fremont place

2018-05-10
city council hearing

process overview.

evolution overview.

naito parkway frontage revisions: removes 18" between property line and building edge

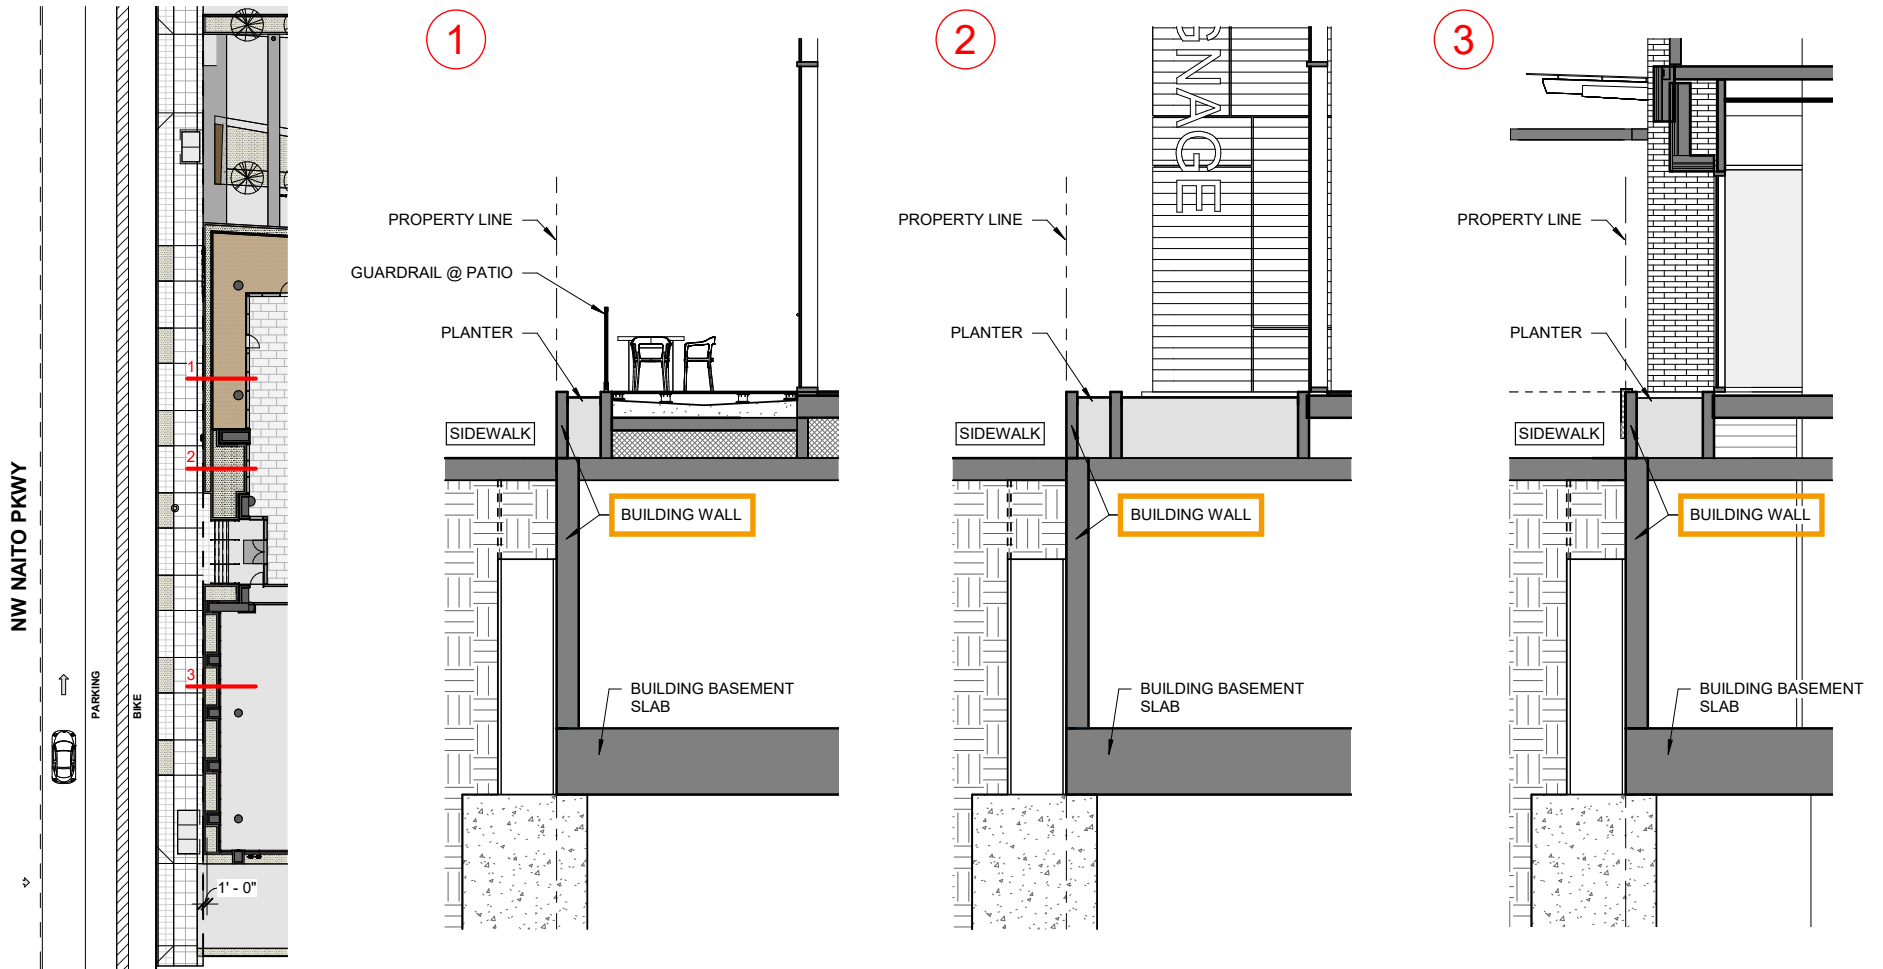
building wall sits along the property line -
no unpaved land between building edge and sidewalk that requires L1 landscape treatment
